**SUBMITTAL TO THE BOARD OF SUPERVISORS
COUNTY OF RIVERSIDE, STATE OF CALIFORNIA**

ITEM
3.33
(ID # 5686)

Approve Addenda to Plans and Specifications; Accept the Low Bid and Award the Contract for the Construction of Traffic Signal at the Intersection of Gilman Springs Road and State Highway 79 Northbound Ramps and Resurfacing Projects in the Gilman Hot Springs Area, CEQA Exempt, 3rd District; [\$589,540 total cost]; Local Funds 100%.

Addendum No. 1
Gilman Springs Rd and SH-79 NB Ramp Traffic Signal and Lighting Project
In the Gilman Hot Springs Area
Project No. C4-0054 and C8-0049
August 9, 2016
Page 4 of 5

LAYOUT
 SHEET NO. L-1
 SHEET 2 OF 2

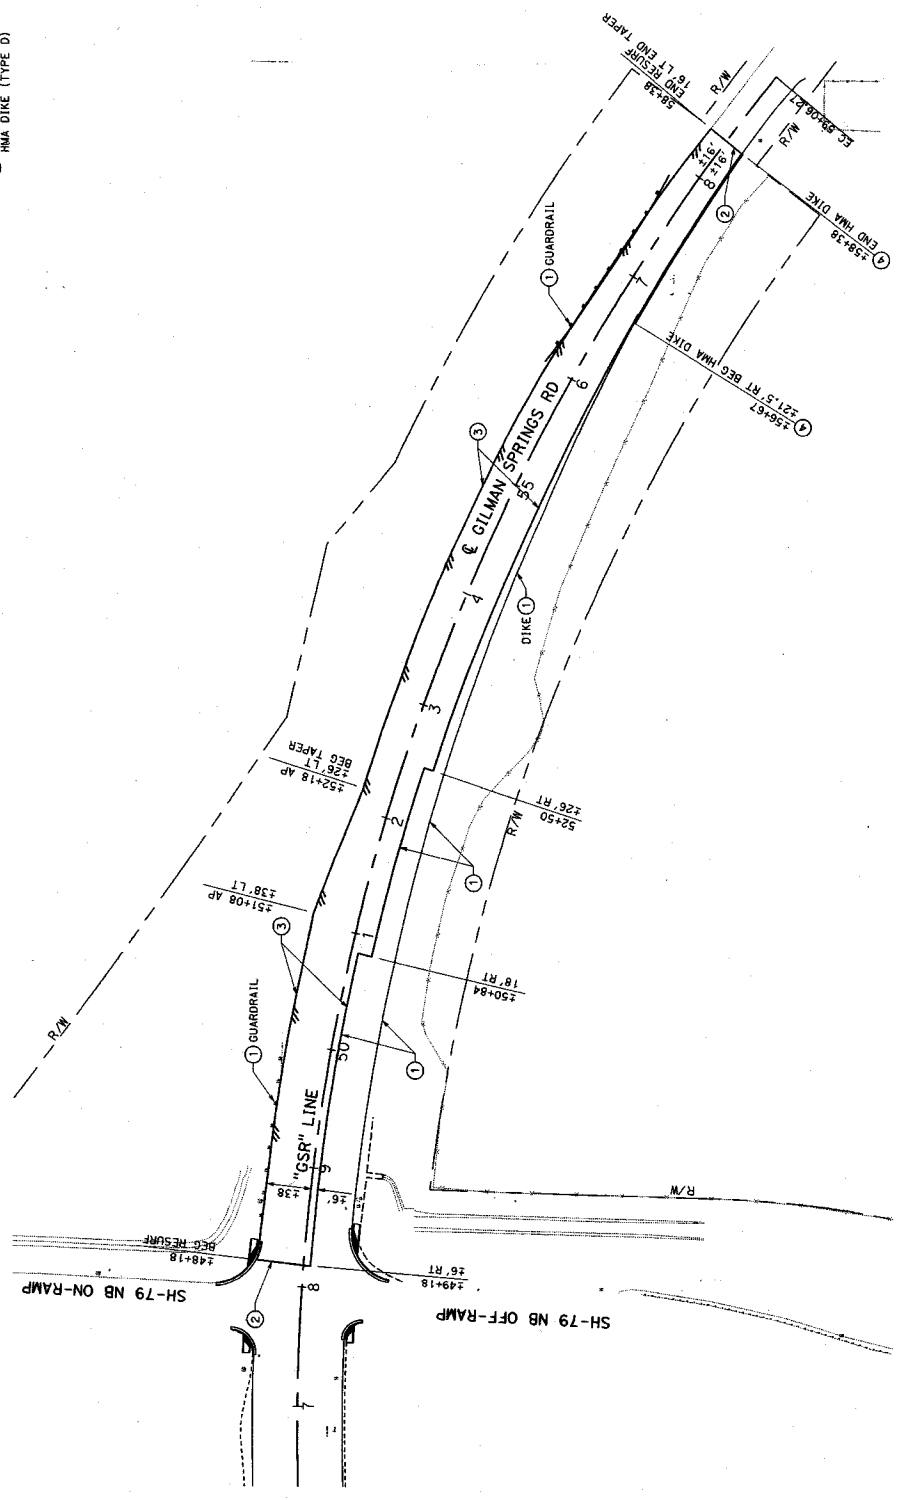
Alternate bid schedule is added to the bid proposal and made part thereof. The scope of alternate bid includes remove and replace of existing AC dike, milling/cold planing existing asphalt concrete (AC) pavement and overlaying with Hot Mix Asphalt concrete (HMA) as specified in the bid book. Any additional work needed for dust abatement, water pollution control, traffic control system, clearing and grubbing and developing water supply for alternate bid schedule shall be considered as included in the similar items of work for base bid and no additional compensation will be allowed. The limit of alternate bid work is shown on the plans enclosed herewith as **Attachment "B"**.

- ① PROTECT
- ② MATCH EXISTING
- ③ MILL EXISTING ASPHALT CONCRETE SURFACE TO A DEPTH OF 0.20'; PLACE 0.20" HOT MIX ASPHALT, TYPE "A" PG 64-10.3
- ④ REMOVE ASPHALT CONCRETE DIKE AND REPLACE WITH CAL TRANS HMA DIKE (TYPE D)

Referred to Plans entitled "Gilman Spring Rd Resurface SR-79 NB Ramps to 1100 Ft E/O" issued by addendum 1 as attachment "B". The construction note No. 3 has been revised as follow to comply with Caltrans encroachment permit requirement.

Revised Construction Note No. 3; MILL EXISTING ASPHALT CONCRETE SURFACE TO A DEPTH OF 0.20'; PLACE 0.20' HOT MIX ASPHALT, TYPE "A" PG 64-28 PM, ¾".
